Accounting for deviation of a test fixture from the reference

(in support of comment #407)

Adee Ran, Cisco

HCB model structure and parameters

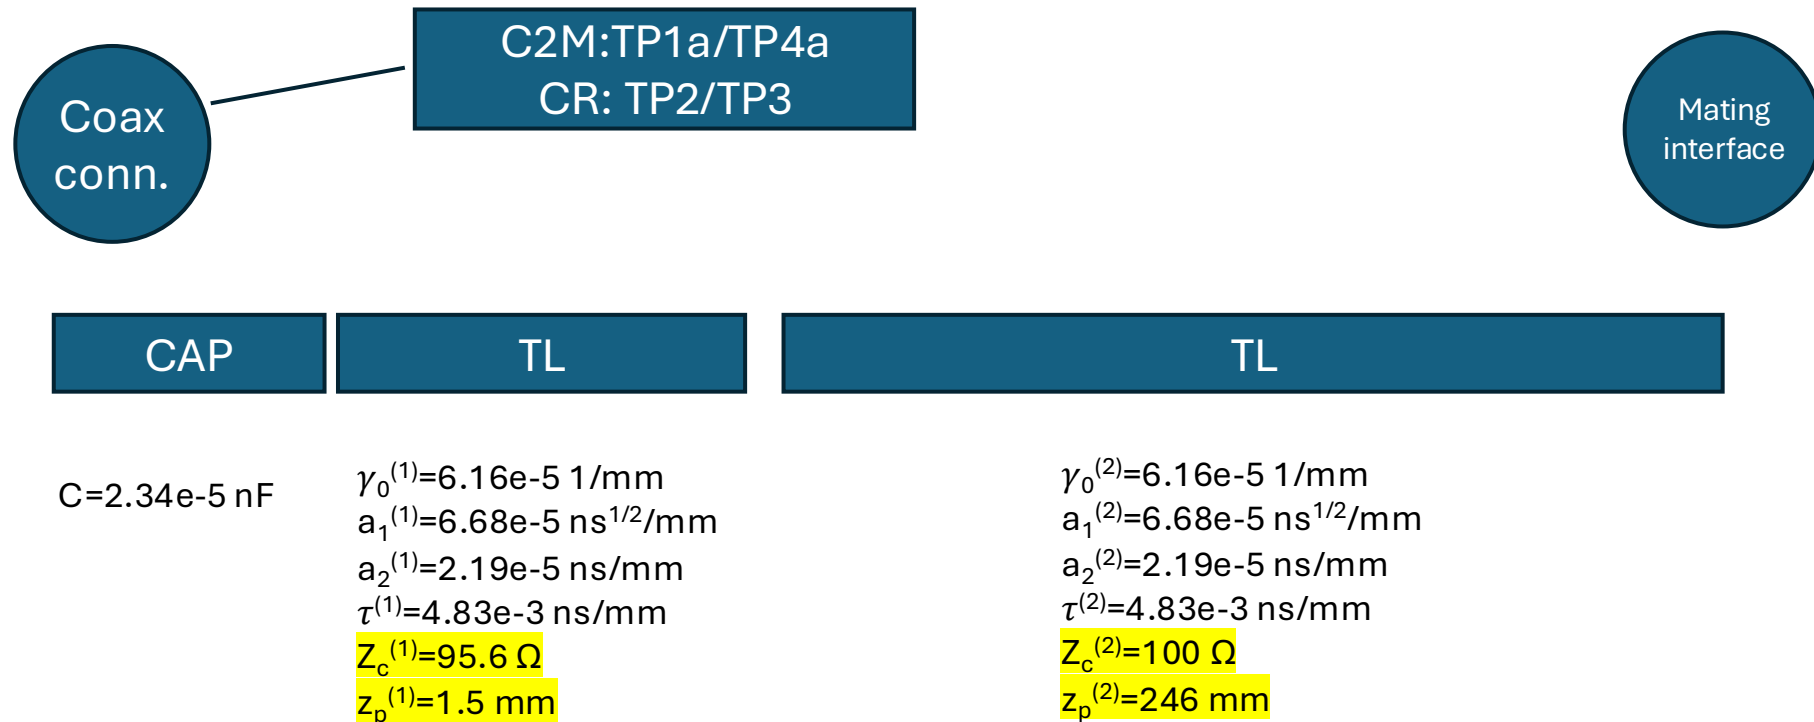
- In 179B.2.1, add the following text and new equation at the end:

The reference insertion loss is approximately achieved by scattering parameters generated by equation (179B-X1) :

$$S = \text{cascade}(S(C_1), S(TL_1), S(TL_2)) \quad (179B-X1)$$

- Add new table 179B-X2 with C and TL parameters from slide 8.

MCB model structure and parameters

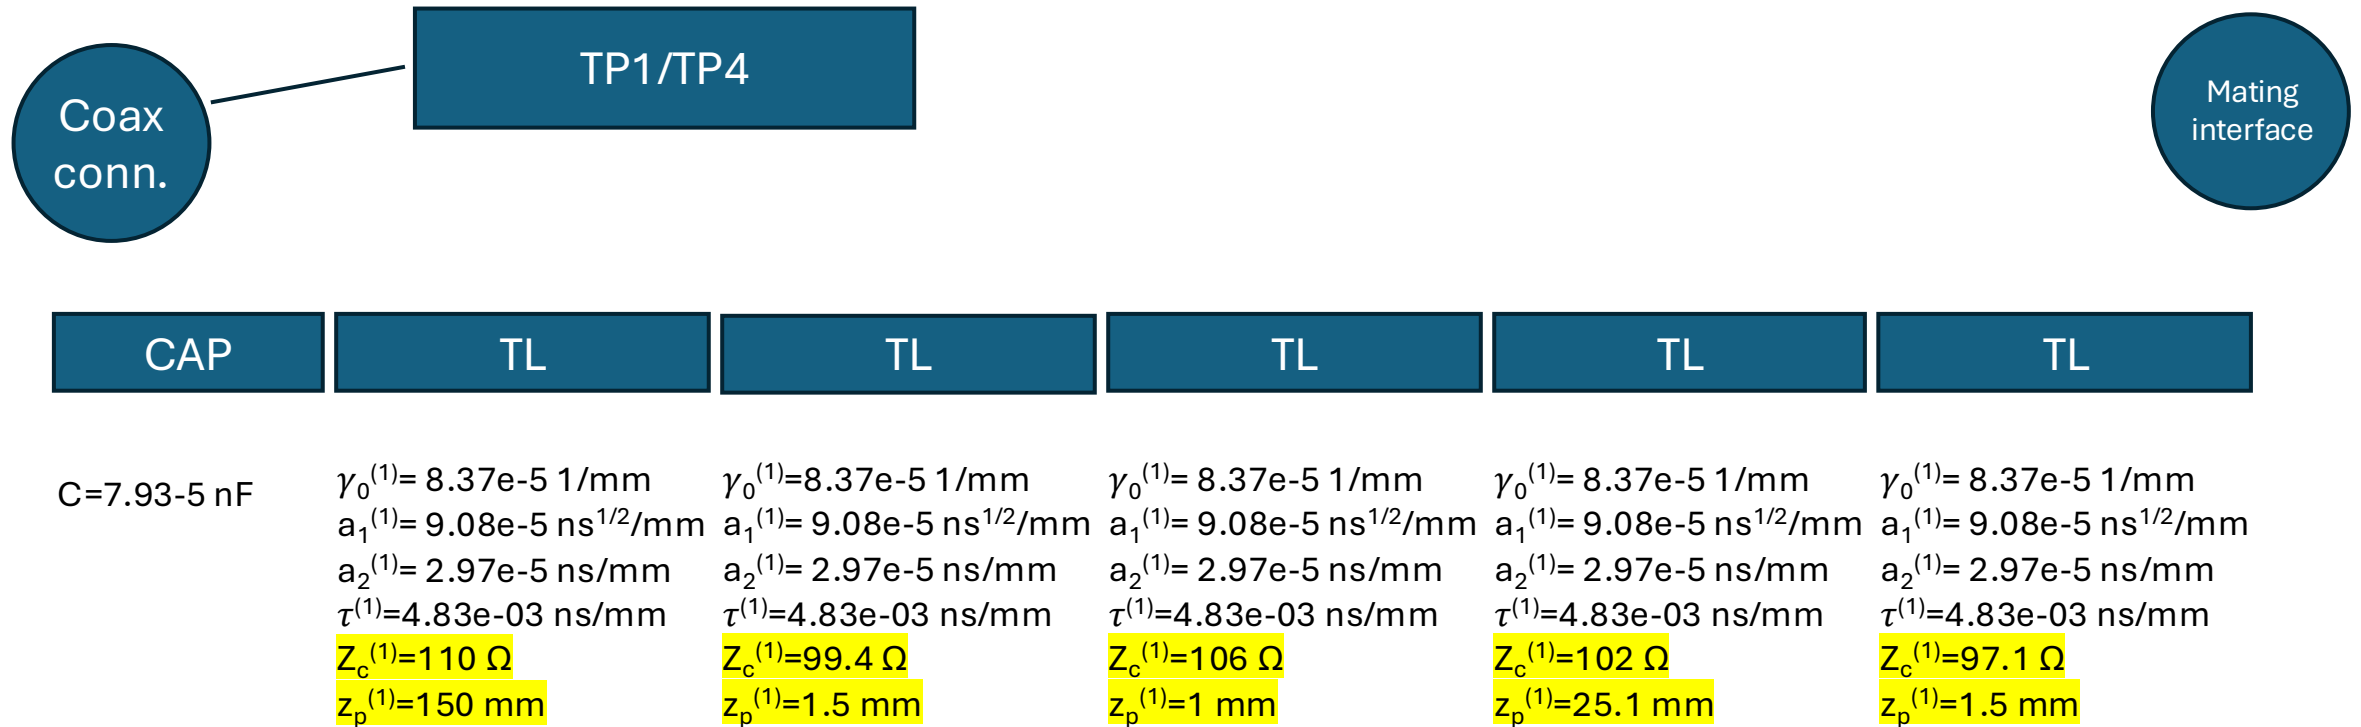
- In 179B.3.1, add the following text and new equation at the end:

The reference insertion loss is approximately achieved by scattering parameters generated by Equation 179B-X3 :

$$S = \text{cascade}(S(C_1), S(TL_1), S(TL_2), S(TL_3), S(TL_4), S(TL_5)) \quad (179B-X3)$$

- Add new table 179B-X4 with C and TL parameters from slide 9.
